Access Compliance Report

Public Rights-of-Way

(Curb Ramps)

Intersection ID: 50729	Main Street: TODDINGTON_LN	Cross Street: ALDERGROVE_RD	Location:	E
ADA ID: 550F7A41AEDE	Ramp Type: PerpDiag	Initial Pass/Fail: Fail	Overall Compliance: No	Severity Score: 10
Codes/Mitigation Info/Possible Solution		Field Measurements/Component Compliance

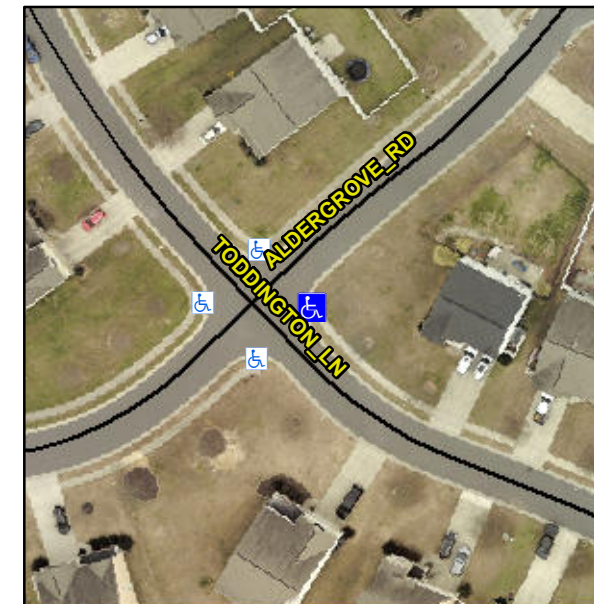
Not Found, R304.5.1, R304.5.3

Compliance	Description	Data	Compliance	Description	Data
N/A	Ramp Length (in)	49.5	Yes	Ramp Slope (%)	8.0
No	Ramp Width (in)	47.0	No	Ramp XSlope (%)	4.6
N/A	Flare Type LT	N/A	N/A	Flare Type RT	N/A
N/A	Flare Slope LT (%)	N/A	N/A	Flare Slope RT (%)	N/A
N/A	Flare Traversable LT?	N/A	N/A	Flare Traversable RT?	N/A
N/A	Landing Length (in)	N/A	N/A	DWS Provided?	N/A
N/A	Landing Width (in)	N/A	N/A	DWS Contrast?	N/A
N/A	Landing Slope (%)	N/A	N/A	DWS Length (in)	N/A
N/A	Landing X Slope (%)	N/A	N/A	DWS Full Width?	N/A
N/A	Landing Curb? (Y/N)	N/A	N/A	DWS Offset (in)	N/A
N/A	Shared Landing?	N/A			
N/A	Gutter Ponding?	N/A	N/A	Gutter Slope (%)	N/A
N/A	Gutter Lip Ht (in)	N/A	N/A	Gutter X Slope (%)	N/A
N/A	Painted X Walk1?	No	N/A	Painted X Walk2?	No
	X Walk 1 Direction	To NW		X Walk 2 Direction	To SW
N/A	X Walk 1 Width (in)	N/A	N/A	X Walk 2 Width (in)	N/A
	X Walk 1 Slope (%)	1.7		X Walk 2 Slope (%)	2.3
	X Walk 1 X Slope (%)	2.5		X Walk 2 X Slope (%)	1.3

Remove & Replace Curb Ramp With Two New Directional Ramps or Equivalent.
